SUBJECT: Potential Manufacturing Problem With Certain Limit Switch Assemblies Used in
ASCO General Controls Hydramotor[®] Actuators.

**POTENTIAL MANUFACTURING PROBLEMS WITH
LIMIT SWITCH ASSEMBLIES USED IN ASCO GENERAL CONTROLS
HYDRAMOTOR® ACTUATORS**

TYPICAL INSTALLATION
NH95 LIMIT SWITCH ASSEMBLY

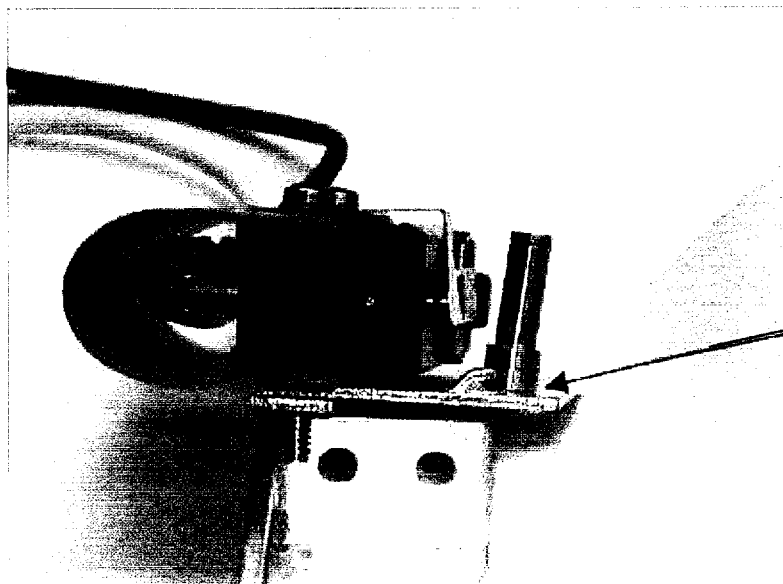
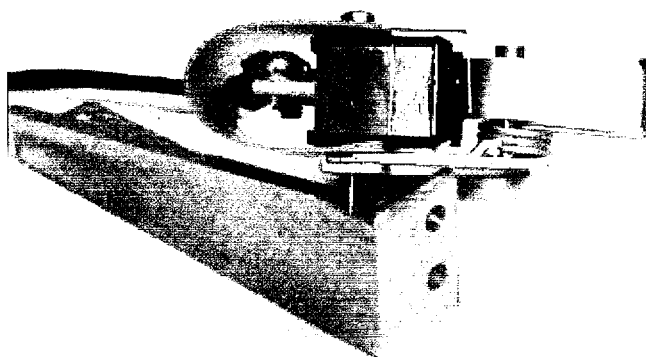
Analysis of the returned Limit Switch Assembly (see attachment 1) revealed that the shaft on which the position sensing lever operates was not secured tightly to the plate, causing wobble of the shaft. This wobble may result in the rotation of the lever past its actuation point, which would leave the switch contacts in the normally open (N.O.) position. This condition will result in the failure of the actuator piston to retract when the Hydramotor® is powered. The shaft is staked to the plate assembly. Manufacturing instructions for this assembly defines the maximum pressure to be applied for the staking press, but no minimum value. This led to variation of the staking process, which resulted in inconsistent and incomplete attachment of the shaft to the plate. (See attachment 2). In addition to the field return, Asco has found several limit switch assemblies in our inventory with this condition.

POINT OF
FAILURE

VIEW SHOWING ANGULATION CONDITION
OF FAILED SHAFT JOINT

VIEW SHOWING LIMIT SWITCH ASSEMBLY
WITH PROPERLY SWAGED SHAFT

ASCO will notify all purchasers of affected product of the potential problem. If the affected product is not in service, ASCO will offer to rework it at our factory at no charge. If the product is in service, ASCO will offer retrofit kits at no charge with complete instructions for installation of new limit switch assemblies. The method of forming this staked joint is being revised to ensure complete and consistent assembly of the shaft to the plate. In addition, the manufacturing instructions are being revised to fully define the parameters of this process as well as the testing necessary to confirm the reliability of the shaft-to-plate joining process.
